INCREMENTAL CHANGE

Release Notification Date: 09/22/2022

SPM 70-48-18 REPLACEMENT OF KELOX STUDS

Figure 1 Removal of Stud

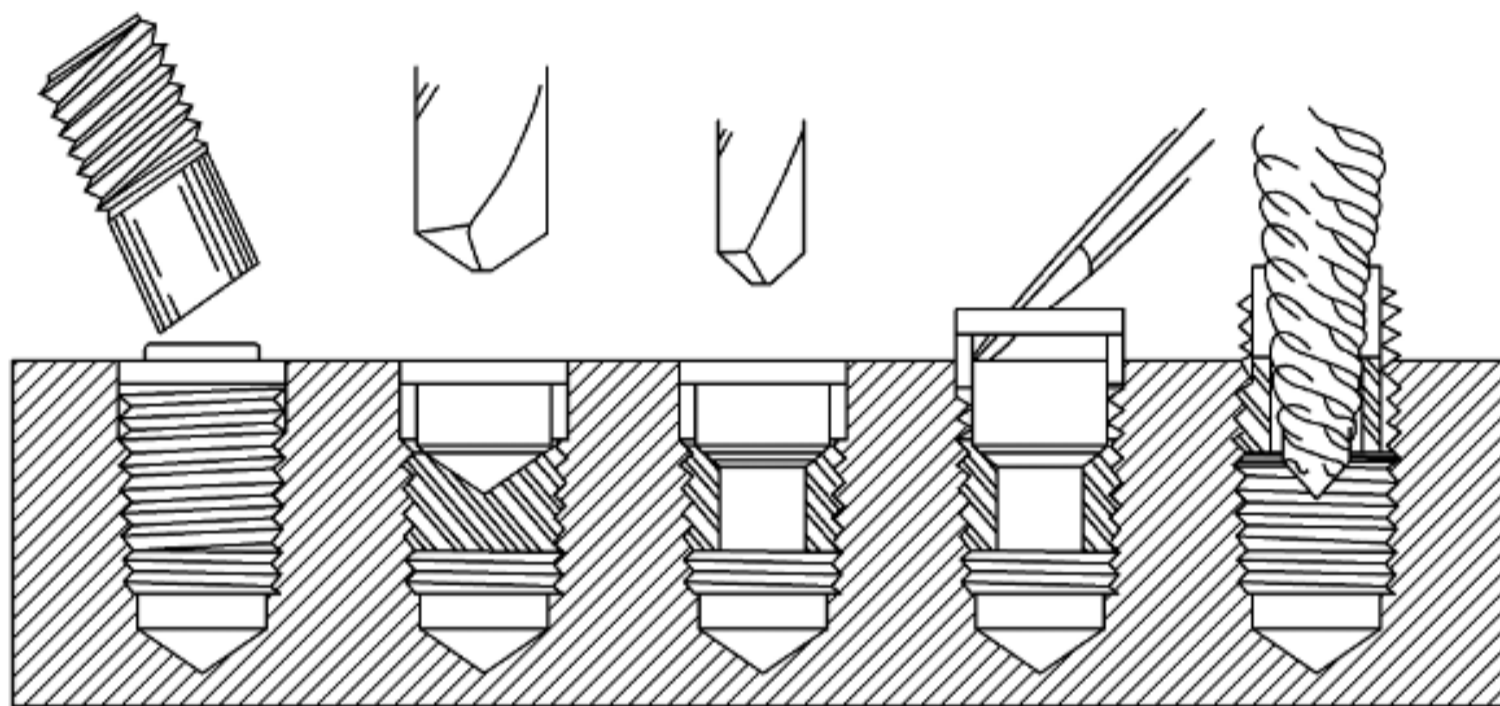
- A. Remove the defective stud. Refer to Figure 1 and as follows:
  - (1) Cut off the flush of stud with surface of the part.
  - (2) Remove defective part and drill out top of the stud. Refer to Table 2 for drill diameter and depth. Use second drill bit of approximately half the diameter of the first to finish drill through. The hardened ring will act as a drill bushing to guide drill.

- (3) Use a sharp pointed tool, remove the key ring.
  - (4) Use the screw extractor to remove stud.
- B. Install the stud. Refer to Figure 2 and as follows:

Figure 2 Installation of Kelox Stud

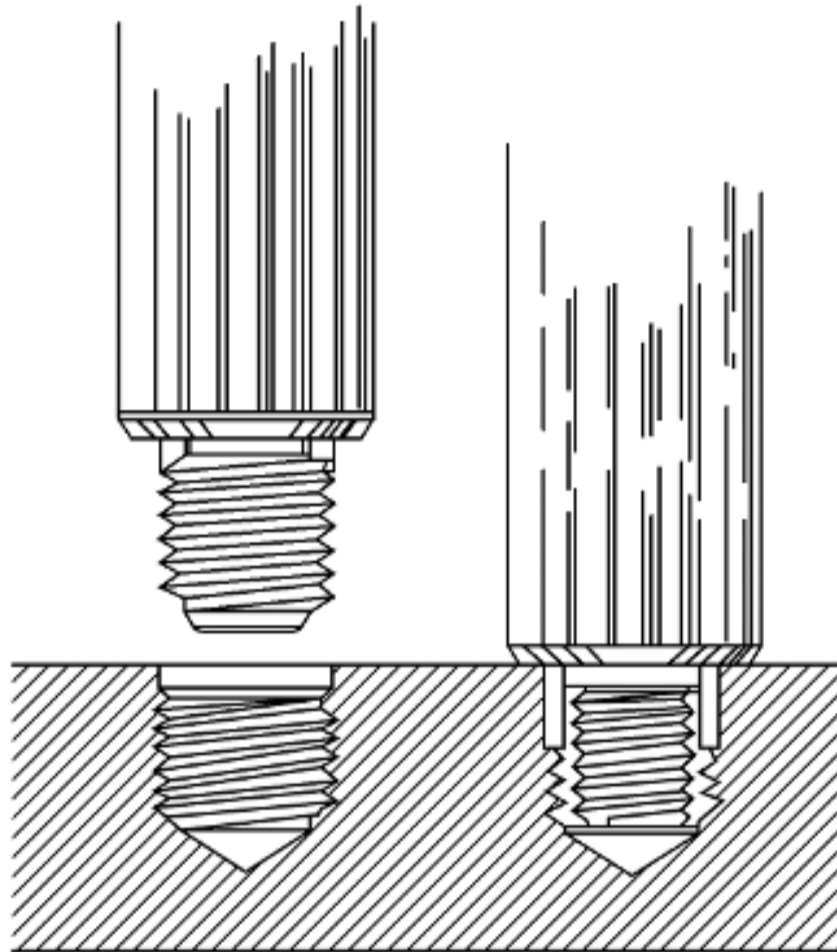
- (1) The threaded hole must be clear and not damaged. Up to one full thread can be missing.
  - (2) Refinish the threaded hole with chromated conversion coating. Refer to TASK 70-43-07-380-007 (70-43-07, Chemical Touch-Up Surface Refinishing Process for Aluminum).

- (3) Coat the external threads with zinc chromate primer C03-001 .
  - (4) Install the replacement stud before primer dries.
  - (5) Screw assembly into tapped hole until keys contact first thread of stud.

- (6) Drive key ring to or slightly below the surface.
